Office Action Summary	Application No. 10/753,730	Applicant(s) NORBERG, JONATHAN	
	Examiner Corey N. Skurdal	Art Unit 3727

DETAILED ACTION***Drawings***

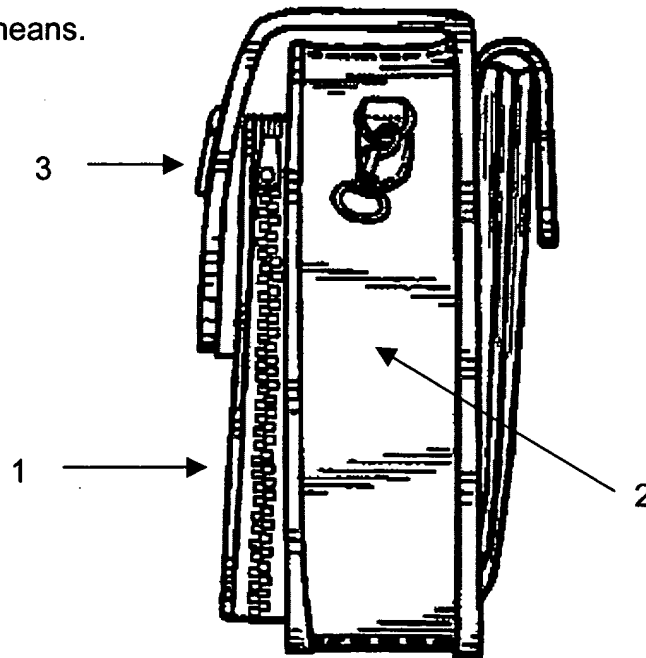
Regarding claims 1 and 6 Boch discloses a personal article holder, which is shown to be releasably secure, with adjusting means about the leg of the user. See figure 1. It can be shown that Boch is also be capable of releasably securing around the upper arm of the user, by means of buckles 13 and elastic strap 11. The personal article holder of Boch includes a plurality of pockets, each having a front and back wall (figure 1, also col. 3 line 25-30), interconnected side walls, a closed off bottom and a open top, each of which is mounted to a base (col. 2 line 91-96). The interconnected sidewalls of Boch are considered to be the stitching found along each side. Each pocket is also shown to be closed off by a flap 6, which can be removably secured to the front of each pocket by fastening means
